C15-2014-0112

**From:** Holly Kincannon ~~Holly@kincannonstudios.com~~  
**Sent:** Wednesday, September 17, 2014 4:53 PM  
**To:** Heldenfels, Leane  
**Subject:** 3102 Lafayette follow-up  
**Attachments:** siteplan.pdf; siteplan info.pdf

**From:** Holly Kincannon ~~holly@kincannonstudios.com~~  
**Sent:** Thursday, September 18, 2014 11:53 AM  
**To:** Heldenfels, Leane  
**Subject:** reconsideration, please.

01 proposed site plan :  
3/32" = 1'-0"

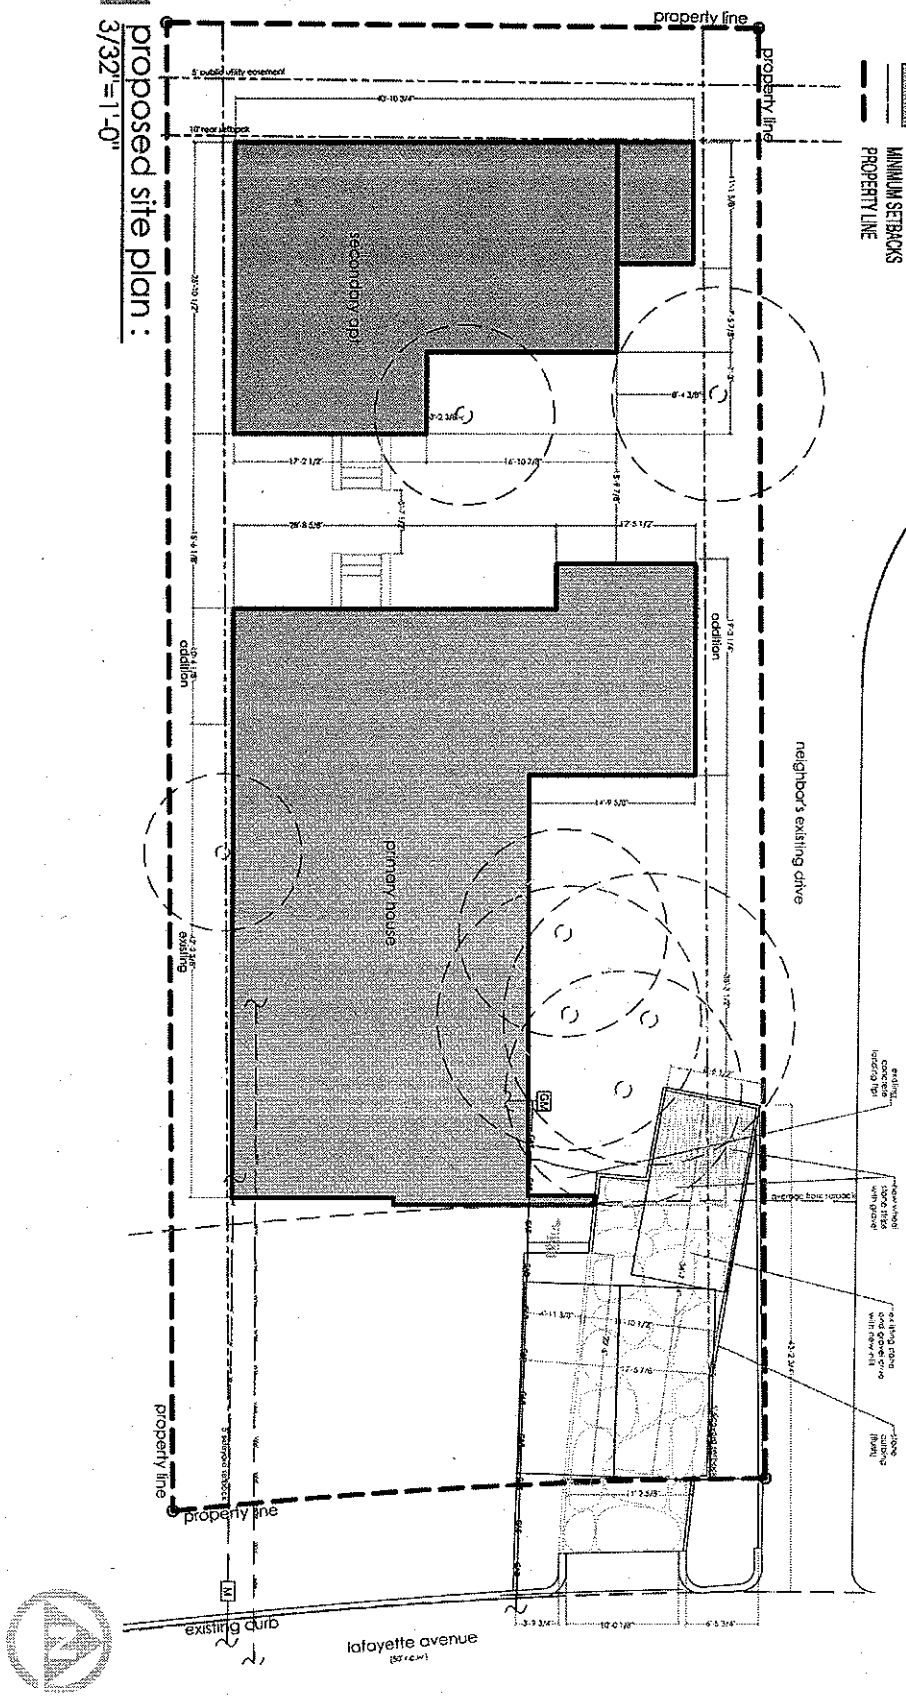
- Withdraw our variance request of eliminating one parking space.
- Withdraw our variance request to not supply a drive.
- And, to comply with BOA/code requirements to change our front yard drive 12' width to 17'-6".

Please see the attached revised site plat (sent 9/17/14) that shows our project meeting the parking required (3 spaces), and providing a drive (versus not providing one in the former plan), but having a drive above 12'.

Thank you for your email. I presume this is the outcome of many discussions with staff and BOA. Please be aware that the layout is permissible and the details of the layout will be finalized via the tree permitting process.
